Omaha Public Power District
444 South 16th Street Mall
Omaha, NE 68102-2247

LIC-15-0069
May 13, 2015

Fort Calhoun Station, Unit No. 1
Renewed Facility Operating License No. DPR-40
NRC Docket No. 50-285

Subject: Omaha Public Power District (OPPD) Response to NRC Request for
Additional Information Regarding Relief Request RR-14

CCW Flex Hose Leak

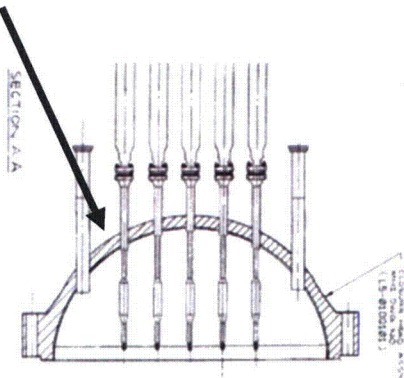
CCW Flex Hose Leakage down CEDM

Component Cooling Water is supplied and returned by a ring header as part of the reactor vessel head work platform. The subject hoses supply and return CCW flow between the CEDM seal assemblies and the ring headers for CEDM cooling. One of the CCW hoses running between CEDMs 3, 7, 8, and 19 developed a leak during the operating cycle. Due to the hose being located above the reactor vessel closure head, the leakage was able to flow onto the surface below the CEDM Drive Assemblies and down the CEDM housings. Evidence of pooling on the top of insulation surface was identified. From this surface, the fluid was able to run down the CEDM housings through insulation and onto head.

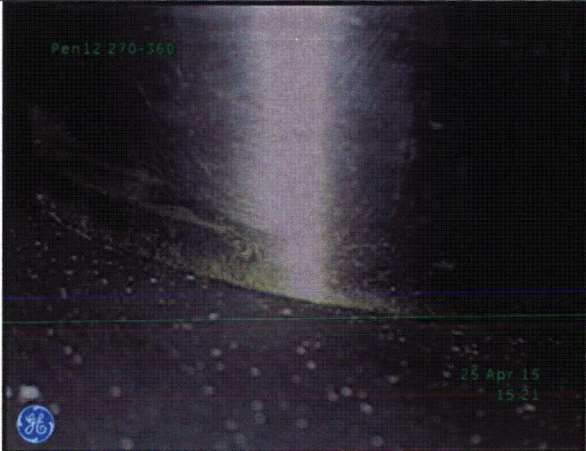
CEDM Nozzle 5	As-Found	As-Left
<p>Question 1 (a) Light Boric Acid dust accumulation around annulus (b) Initial Evaluation as Not Relevant later re-evaluated as Relevant</p> <p>Question 2 (b) See Answer 3 (c) Sample not performed.</p> <p>Question 3 The photos from the initial bare metal inspection on all four sides show a small amount of light dust residue collected around the penetration annulus, more concentrated in the downslope side in the protective leeward side of the penetration nozzle. There is light discoloration of the nozzle itself on the 90-180 view. The granule paths in the dust show that drifting has occurred downslope on the RVH, as one would expect from blown dust on a sloped surface.</p> <p>Question 4 See Answer 3 for basis of not evaluating per -3142.1(b)(1) of CC N-729-1 *Leak Source determined RC-100 packing leak (WO #551054)*</p>

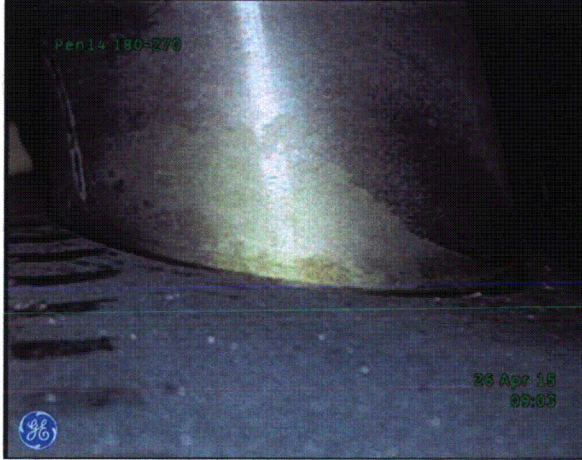
CEDM Nozzle 6	As-Found	As-Left
<p>Question 1 (a) Little to no residue accumulation. Slight discoloration around nozzle. (b) Initial Evaluation as Not Relevant later re-evaluated as Relevant</p> <p>Question 2 (b) See Answer 3 (c) Sample not performed.</p> <p>Question 3 Photos from the 0-90 and 90-180 views of the initial bare metal inspection show little-to-no residue or dust collected around the penetration annulus. The nozzle itself is clean, albeit lightly discolored on the bottom and with a large glare from the camera flash. The annulus itself appears slightly lighter than surrounding bare metal, but no accumulation or BA crystals are present.</p> <p>Question 4 See Answer 3 for basis of not evaluating per -3142.1(b)(1) of CC N-729-1 *Leak Source determined RC-100 packing leak (WO #551054)* *Post Cleaning VE determined acceptable*</p>

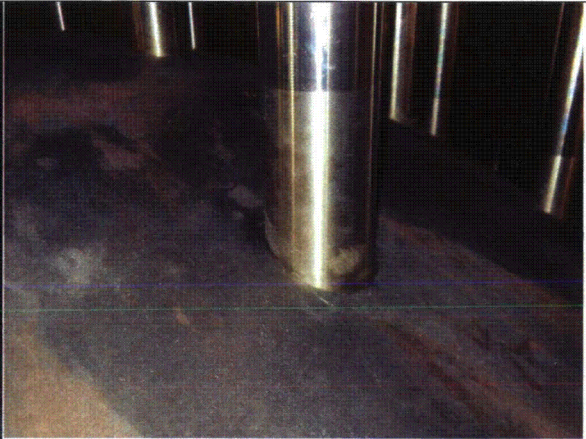
CEDM Nozzle 8	As-Found	As-Left
<p>Question 1 (a) Buildup of discolored deposits around and on nozzle (b) Relevant</p> <p>Question 2 (b) Deposits show flow conditions from above with visible leakage indications from insulation. Deposits have yellowish tint to them. Known CCW leak from flex hose near CEDM 3 and 8 in upper seal housing flowing down CEDM 3 and 8 and pooling on insulation and further leakage on reactor vessel head near surrounding penetrations. See plan view of page one of Attachment 2. (c) See chemistry description at end of report.</p> <p>Question 3 N/A - Relevant</p> <p>Question 4 N/A – Relevant with an evaluation per - 3142.1(b)(1) of CC N-729-1 *Leak Source determined CCW Flex Hose leak near CEDM 3/8 (WR #224908)*</p>	 <p>The image shows a close-up of a nozzle area with significant yellowish deposits. A GE logo is visible in the bottom left corner. Text overlays include 'PART 270-388' in the top left and '58 Apr 15 09 18' in the bottom right.</p>	 <p>The image shows the same nozzle area after inspection, appearing clean and free of the deposits seen in the 'As-Found' image.</p>

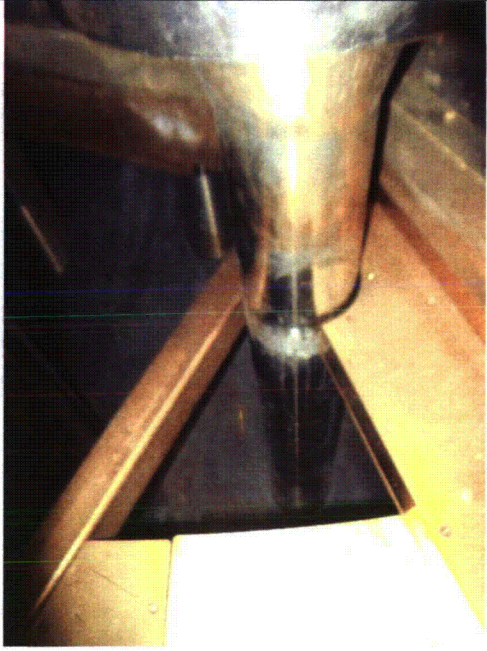
CEDM Nozzle 18	As-Found	As-Left
<p>Question 1 (a) Indication of small amounts of dust deposits on side and base of penetration. No corrosion. Yellow film on housing is from CCW. (b) Initial Evaluation as Not Relevant later re-evaluated as Relevant</p> <p>Question 2 (b) See Answer 3 (c) Sample not performed.</p> <p>Question 3 The initial bare metal inspection photos document no large accumulations or deposits of residue. The yellow stain on the CEDM housing is indicative of CCW. A light dust residue and loose particles is shown to have settled in the annulus region on the upslope side of the penetration where it is relatively protected from air currents and cannot drift down slope in any vibration-induced drift. This residue extends downslope along the penetration sides where it has been able to drift down. Again, from this view there are no large deposits or any large stains. There is slight discoloration of the bottom of the nozzle and a very small accumulation of heavier residue in the down slope of the penetration, but neither is indicative of a BA leak source from the penetration.</p> <p>Question 4 See Answer 3 for basis of not evaluating per -3142.1(b)(1) of CC N-729-1 *Leak Source determined CCW Flex Hose leak near CEDM 3/8 (WR #224908)* *Post Cleaning VE determined acceptable*</p>	 <p>This photograph shows the 'As-Found' condition of the CEDM Nozzle 18. It features a dark, cylindrical metal component with a blue GE logo in the upper left. The surface is covered with a fine layer of white dust and small white particles, particularly concentrated in the annular region. A vertical green timestamp 'Pen18 270 360' is visible on the right side, and a green timestamp '25 April 15 15:54' is on the left.</p>	 <p>This photograph shows the 'As-Left' condition of the CEDM Nozzle 18. It provides a close-up view of the nozzle's tip, which is a polished, conical metal piece. The surrounding metal housing is dark and shows some surface texture and slight discoloration.</p>

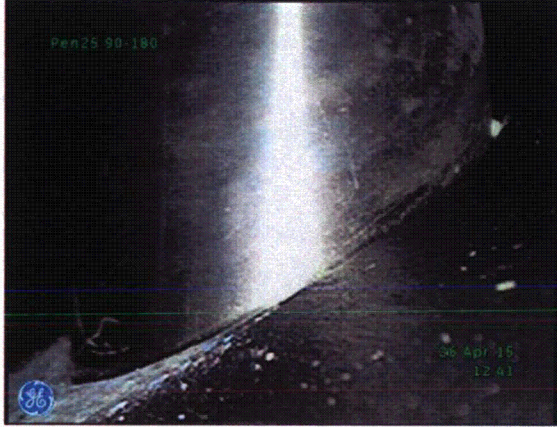
CEDM Nozzle 19	As-Found	As-Left
<p>Question 1 (a) Indication of possible Boric Acid deposits on side and base of entire penetration (b) Relevant</p> <p>Question 2 (b) Deposits show flow conditions from above and have a yellowish tint to them. Visible leakage showed flow from insulation above. Known CCW leak from flex hose near CEDM 3 and 8 in upper seal housing flowing down CEDM 3 and 8 and pooling on insulation and further leakage on reactor vessel head near surrounding penetrations. See plan view of page one of Attachment 2. Post vacuuming VE showed no sign of degradation/nozzle leakage. (c) See chemistry description at end of report.</p> <p>Question 3 N/A - Relevant</p> <p>Question 4 N/A – Relevant with an evaluation per - 3142.1(b)(1) of CC N-729-1 *Leak Source determined CCW Flex Hose leak near CEDM 3/8 (WR #224908)*</p>

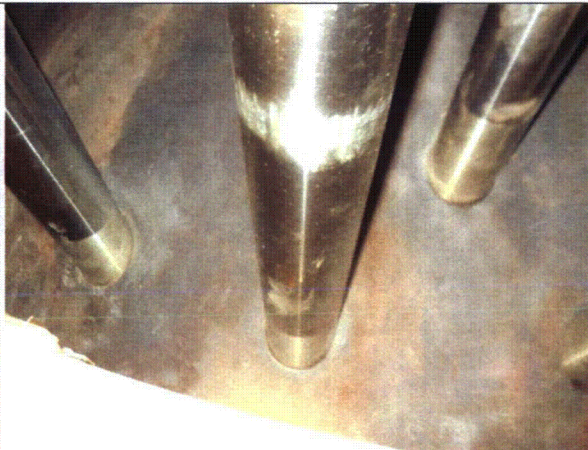
CEDM Nozzle 20	As-Found	As-Left
<p>Question 1 (a) Indication of small amounts of dust deposits on side and base of penetration. No corrosion. Yellow film is indicative of CCW. (b) Initial Evaluation as Not Relevant later re-evaluated as Relevant</p> <p>Question 2 (b) See Answer 3 (c) Sample not performed.</p> <p>Question 3 The initial bare metal inspection photos document no large accumulations or deposits of residue. The 0-90 and 180-270 views show no accumulation of any residue on the upslope portion and sides of the penetration; the darker bare metal of the RVH is clearly apparent. The 90-180 view shows a light dusting of residue that has settled down slope in the protective lee ward side of the annulus, but there is no significant discoloration or any other indication of a leak source.</p> <p>Question 4 See Answer 3 for basis of not evaluating per -3142.1(b)(1) of CC N-729-1 *Leak Source determined CCW Flex Hose leak near CEDM 3/8 (WR #224908)* *Post Cleaning VE determined acceptable*</p>

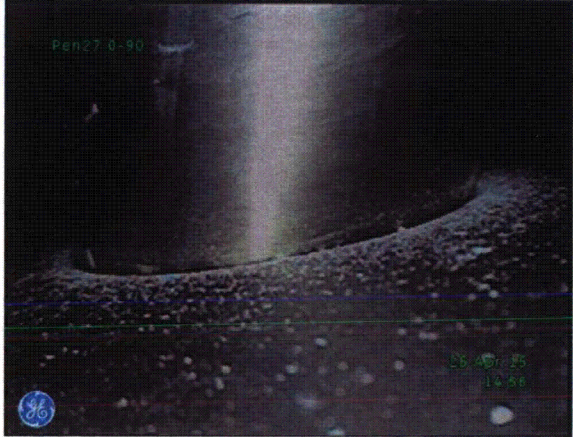
CEDM Nozzle 21	As-Found	As-Left
<p>Question 1 (a) Indication of possible Boric Acid deposits on base of penetration (b) Relevant</p> <p>Question 2 (b) Deposits indicate light dusting in a blowing fashion in the direction of 90-180 degree. Known RCS leak from RC-100 packing near CEDM #21 in the 270-360 degree direction. Dusting due to blown leakage from RC-100. (c) Sample not performed.</p> <p>Question 3 N/A - Relevant</p> <p>Question 4 N/A – Relevant with an evaluation per - 3142.1(b)(1) of CC N-729-1 *Leak Source determined RC-100 packing leak (WO #551054)*</p>	 <p>The image shows the base of a nozzle with a dark, textured surface. A bright light source from the top left creates a strong glare. A GE logo is visible in the bottom left corner. Text overlays include 'Pen21 90-180' in green at the top left and '15 Oct 14 13:45' in green at the bottom right.</p>	 <p>The image shows the base of a nozzle with a dark, textured surface. A bright light source from the top left creates a strong glare. The surface appears slightly different from the 'As-Found' image.</p>

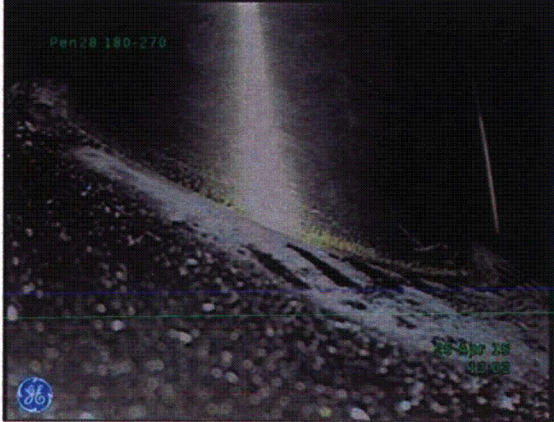
CEDM Nozzle 22	As-Found	As-Left
<p>Question 1 (a) Indication of small amounts of dust deposits on side and base of penetration. No corrosion. Yellow film is indicative of CCW. (b) Initial Evaluation as Not Relevant later re-evaluated as Relevant</p> <p>Question 2 (b) See Answer 3 (c) Sample not performed.</p> <p>Question 3 The initial bare metal inspection photos document no large accumulations or deposits of residue. The 0-90 and 180-270 views show no accumulation of any residue on the upslope portion and sides of the penetration; the darker bare metal of the RVH is clearly apparent although there are a few small granules upslope of the penetration. These granules have settled there from circulation within the shroud; there is no leakage above which could have deposited them. The 90-180 view shows a light dusting of residue that has settled down slope in the protective leeward side of the annulus, and there is only slight discoloration of the nozzle in the 0-90 view.</p> <p>Question 4 See Answer 3 for basis of not evaluating per -3142.1(b)(1) of CC N-729-1 *Leak Source determined CCW Flex Hose leak near CEDM 3/8 (WR #224908)* *Post Cleaning VE determined acceptable*</p>

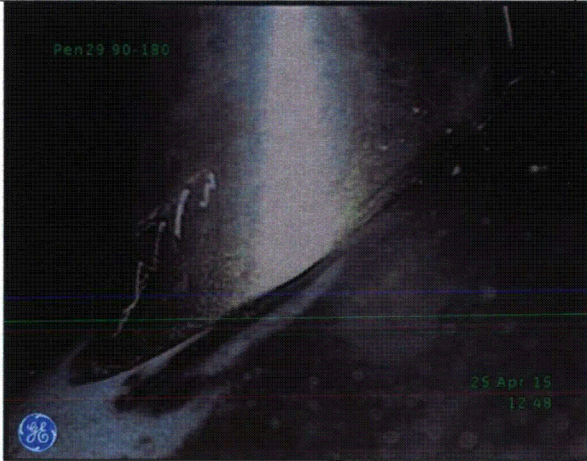
CEDM Nozzle 23	As-Found	As-Left
<p>Question 1 (a). Indication of possible Boric Acid deposits on base of penetration (b) Relevant</p> <p>Question 2 (b) Deposits indicate leakage flow down the head, past the penetration. The leak path is up the curvature of the head from the penetration. The leak source appears to be the known CCW leak from the flex hose near CEDM 3 and 8 in upper seal housing which is then flowing down the curvature of the head to Nozzle 23. See plan view for location (c) See chemistry description at end of report.</p> <p>Question 3 N/A - Relevant</p> <p>Question 4 N/A – Relevant with an evaluation per - 3142.1(b)(1) of CC N-729-1 *Leak Source determined CCW Flex Hose leak near CEDM 3/8 (WR #224908)*</p>

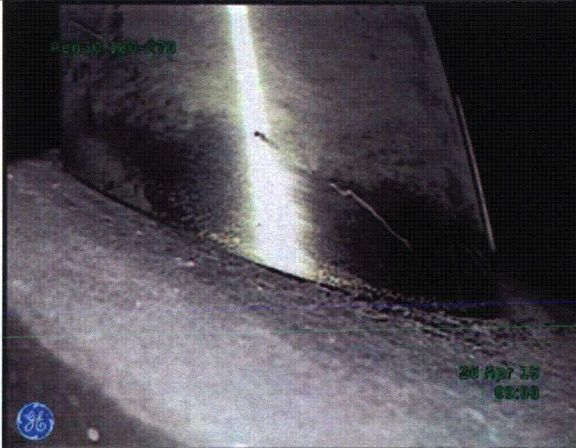
CEDM Nozzle 24	As-Found	As-Left
<p>Question 1 (a) Indication of possible Boric Acid deposits on base of penetration (b) Relevant Question 2 (b) Deposits indicate leakage flow down the head past the penetration. The leak path appears to be up the curvature of the head from the penetration. The leak source appears to be the known CCW leak from the flex hose near CEDM 3 and 8 in upper seal housing. This appears to be flowing down CEDM 3 and 8, which is pooling on insulation. (c) Sample not performed. Question 3 N/A - Relevant Question 4 N/A – Relevant with an evaluation per - 3142.1(b)(1) of CC N-729-1 *Leak Source determined CCW Flex Hose leak near CEDM 3/8 (WR #224908)*</p>	 <p>The photograph shows the base of a metal penetration in a dark, curved surface. There are several small, white, crystalline deposits at the base of the penetration. A green label in the top left corner reads 'Pen24 278-358'. A GE logo and the date '26 Apr 15 10:14' are visible in the bottom right corner.</p>	 <p>The photograph shows the same area as the 'As-Found' image, but the white deposits have been removed, leaving a clean metal surface. The nozzle is now clear and shiny.</p>

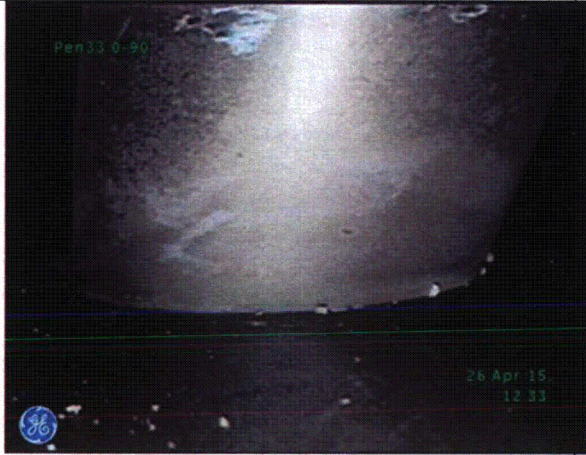
CEDM Nozzle 27	As-Found	As-Left
<p>Question 1 (a). Indication of possible Boric Acid deposits on base of penetration (b). Relevant</p> <p>Question 2 (b). Deposits are of light dusting show indication of being blown around penetration and collecting around the penetration. Known RCS leak from RC-100 packing near 270-360 degree direction. Dusting due to blown leakage from RC-100. (c) Sample not performed.</p> <p>Question 3 N/A - Relevant</p> <p>Question 4 N/A – Relevant with an evaluation per - 3142.1(b)(1) of CC N-729-1 *Leak Source determined RC-100 packing leak (WO #551054)*</p>

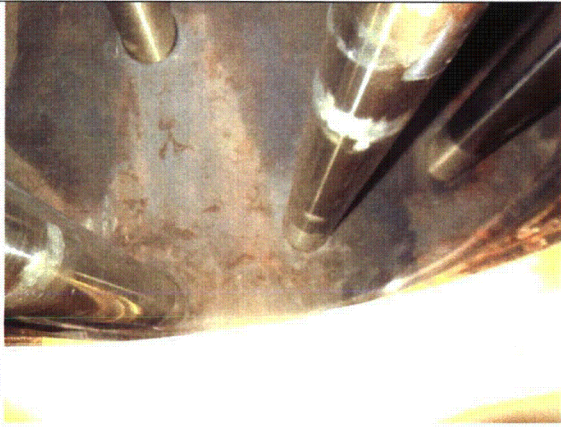
CEDM Nozzle 28	As-Found	As-Left
<p>Question 1 (a). Indication of possible Boric Acid deposits on base of penetration (b). Relevant</p> <p>Question 2 (b). Deposits are of light dusting showing indication of being blown around penetration and collecting around the penetration. Known RCS leak from RC-100 packing near 270-360 degree direction. Dusting due to blown leakage from RC-100. (c) Sample not performed.</p> <p>Question 3 N/A - Relevant</p> <p>Question 4 N/A – Relevant with an evaluation per - 3142.1(b)(1) of CC N-729-1 *Leak Source determined RC-100 packing leak (WO #551054)*</p>

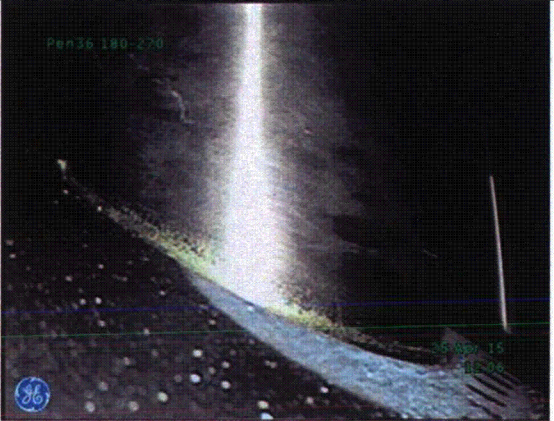
CEDM Nozzle 30	As-Found	As-Left
<p>Question 1 (a). Indication of possible Boric Acid deposits on base of penetration (b). Relevant</p> <p>Question 2 (b). Deposits are of light dusting showing indication of being blown around the penetration and collecting around the penetration. Known RCS leak from RC-100 peaking near 270-360 degree direction. Dusting due to blown leakage from RC-100. (c) Sample not performed.</p> <p>Question 3 N/A - Relevant</p> <p>Question 4 N/A – Relevant with an evaluation per - 3142.1(b)(1) of CC N-729-1 *Leak Source determined RC-100 packing leak (WO #551054)*</p>	 <p>The photograph shows a close-up of a metal nozzle (CEDM Nozzle 30) with a visible penetration. Light-colored dusting or deposits are visible around the base of the penetration. A GE logo is visible in the bottom left corner of the image.</p>	 <p>The photograph shows the same nozzle after cleaning. The dusting deposits have been removed, and the metal surface appears cleaner. A yellow object is visible in the background.</p>

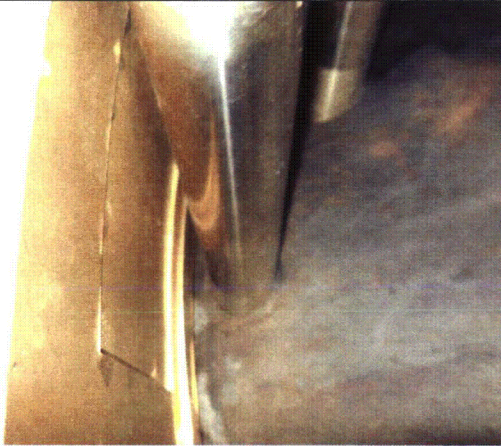
CEDM Nozzle 32	As-Found	As-Left
<p>Question 1 (a). Indication of possible Boric Acid deposits on base of penetration (b). Relevant</p> <p>Question 2 (b). Deposits indicate leakage flow down the head past penetration. The leak path is up the curvature of the head from the penetration. The leak source appears to be the known CCW leak from the flex hose near CEDM 3 and 8 in upper seal housing which is then flowing down the curvature of the head to Nozzle 32. See plan view for location (c) See chemistry report at end of report</p> <p>Question 3 N/A - Relevant</p> <p>Question 4 N/A – Relevant with an evaluation per - 3142.1(b)(1) of CC N-729-1 *Leak Source determined CCW Flex Hose leak near CEDM 3/8 (WR #224908)*</p>

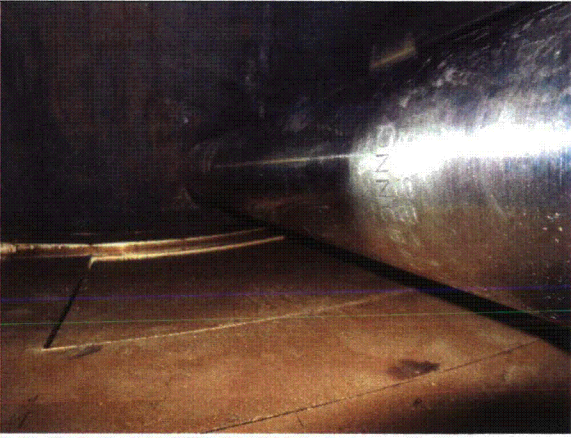
CEDM Nozzle 33	As-Found	As-Left
<p>Question 1 (a). Indication of possible Boric Acid deposits on base of penetration (b). Relevant</p> <p>Question 2 (b). Deposits indicate leakage flow down the head past penetration. Leak path up the curvature of the head from the penetration. Known CCW leak from flex hose near CEDM 3 and 8 in upper seal housing flowing down CEDM 3 and 8 and pooling on insulation and further leakage on reactor vessel head near surrounding penetrations. Flow from CCW flex hose leakage through penetrations above penetration #33 as source. (c) Sample not performed.</p> <p>Question 3 N/A - Relevant</p> <p>Question 4 N/A – Relevant with an evaluation per - 3142.1(b)(1) of CC N-729-1 *Leak Source determined CCW Flex Hose leak near CEDM 3/8 (WR #224908)*</p>

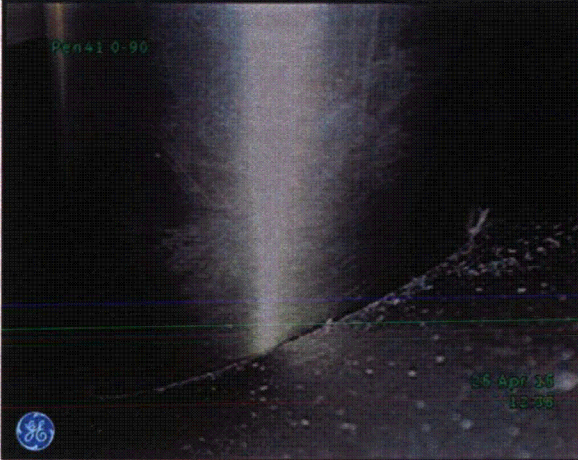
CEDM Nozzle 35	As-Found	As-Left
<p>Question 1 (a). Indication of possible Boric Acid deposits on base of penetration (b). Relevant</p> <p>Question 2 (b). Deposits indicate leakage flow down the head past penetration. Leak path up the curvature of the head from the penetration. Known CCW leak from flex hose near CEDM 3 and 8 in upper seal housing flowing down CEDM 3 and 8 and pooling on insulation and further leakage on reactor vessel head near surrounding penetrations. Flow from CCW flex hose leakage through penetrations above penetration #35 as source. (c) Sample not performed.</p> <p>Question 3 N/A - Relevant</p> <p>Question 4 N/A – Relevant with an evaluation per - 3142.1(b)(1) of CC N-729-1 *Leak Source determined CCW Flex Hose leak near CEDM 3/8 (WR #224908)*</p>

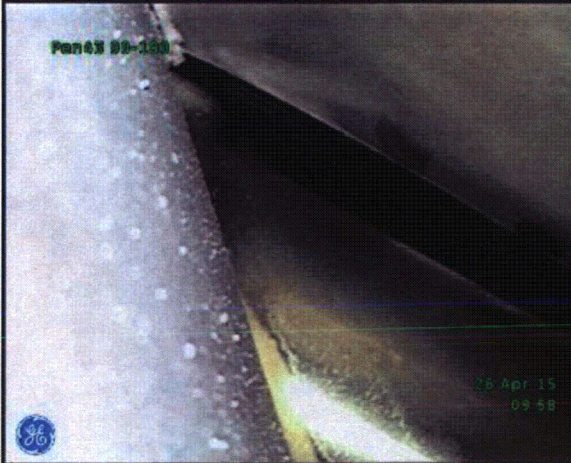
CEDM Nozzle 37	As-Found	As-Left
<p>Question 1 (a). Indication of possible Boric Acid deposits on base of penetration. (b). Relevant</p> <p>Question 2 (b) Deposits indicate light dusting in a blowing fashion in the direction of 090-180 degree. Known RCS leak from RC-100 packing near CEDM #37 in the 270-360 degree direction. Dusting due to blown leakage from RC-100. (c) Sample not performed.</p> <p>Question 3 N/A - Relevant</p> <p>Question 4 N/A – Relevant with an evaluation per - 3142.1(b)(1) of CC N-729-1 *Leak Source determined RC-100 packing leak (WO #551054)*</p>

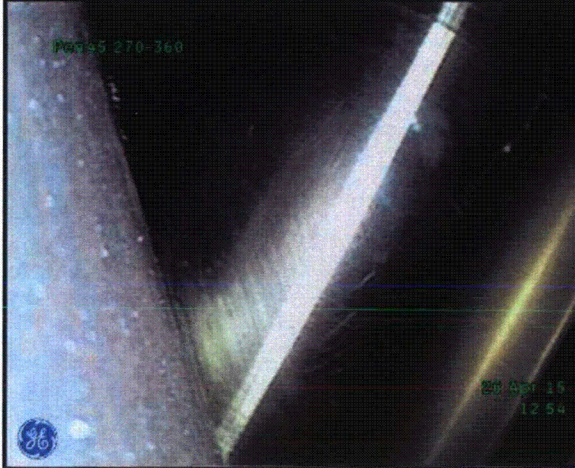
CEDM Nozzle 39	As-Found	As-Left
<p>Question 1 (a). Indication of possible Boric Acid deposits on base of penetration (b). Relevant</p> <p>Question 2 (b). Deposits indicate leakage flow down the head past penetration. Leak path identified as up the curvature of the head from the penetration. Known CCW leak from flex hose near CEDM 3 and 8 in upper seal housing flowing down CEDM 3 and 8 and pooling on insulation and further leakage on reactor vessel head near surrounding penetrations. Flow from CCW flex hose leakage through penetrations above penetration #39 as source (c) Sample not performed.</p> <p>Question 3 N/A - Relevant</p> <p>Question 4 N/A – Relevant with an evaluation per - 3142.1(b)(1) of CC N-729-1 *Leak Source determined CCW Flex Hose leak near CEDM 3/8 (WR #224908)*</p>

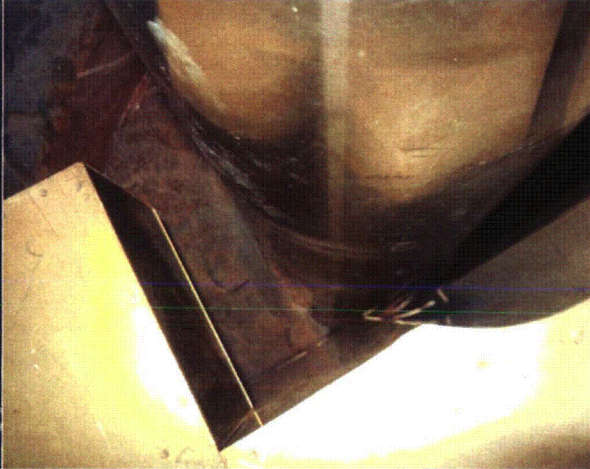
CEDM Nozzle 40	As-Found	As-Left
<p>Question 1 (a). Indication of possible Boric Acid deposits on base of penetration (b). Relevant</p> <p>Question 2 (b). Deposits indicate light dusting in a blowing fashion in the direction of 180-270 degree. Known RCS leak from RC-100 packing near CEDM #40 in the 270-360 degree direction. Dusting due to blown leakage from RC-100. (c) Sample not performed.</p> <p>Question 3 N/A - Relevant</p> <p>Question 4 N/A – Relevant with an evaluation per - 3142.1(b)(1) of CC N-729-1 *Leak Source determined RC-100 packing leak (WO #551054)*</p>

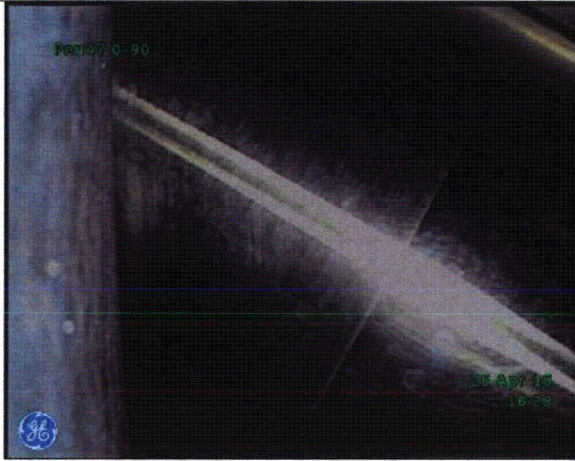
CEDM Nozzle 41	As-Found	As-Left
<p>Question 1 (a). Indication of possible Boric Acid deposits on base of penetration (b). Relevant</p> <p>Question 2 (b). Deposits indicate light dusting in a blowing fashion in the direction of 090-180 degree. Known RCS leak from RC-100 packing near CEDM #41 in the 270-360 degree direction. Dusting due to blown leakage from RC-100. (c) Sample not performed.</p> <p>Question 3 N/A - Relevant</p> <p>Question 4 N/A – Relevant with an evaluation per - 3142.1(b)(1) of CC N-729-1 *Leak Source determined RC-100 packing leak (WO #551054)*</p>

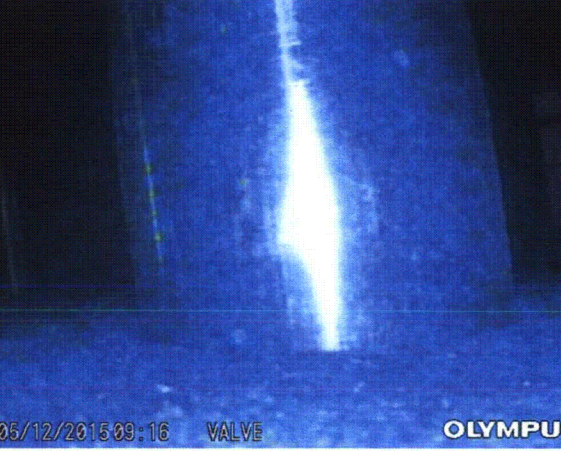
ICI Nozzle 42	As-Found	As-Left
<p>Question 1 (a). Indication of possible light amount of Boric Acid deposits around base of penetration (b). Initial Evaluation as Not Relevant later re-evaluated as Relevant</p> <p>Question 2 (b). See Answer 3 (c). Sample not performed.</p> <p>Question 3 The angle of the slope around penetration 42 is very steep which would allow deposits from above to easily collect around it. The deposits found were light and the deposits near the annulus were from the high point of the RVCH sloop around nozzle 42.</p> <p>Question 4 See Answer 3 for basis of not evaluating per -3142.1(b)(1) of CC N-729-1 *Leak Source determined RC-100 packing leak (WO #551054)* *Post Cleaning VE determined acceptable*</p>
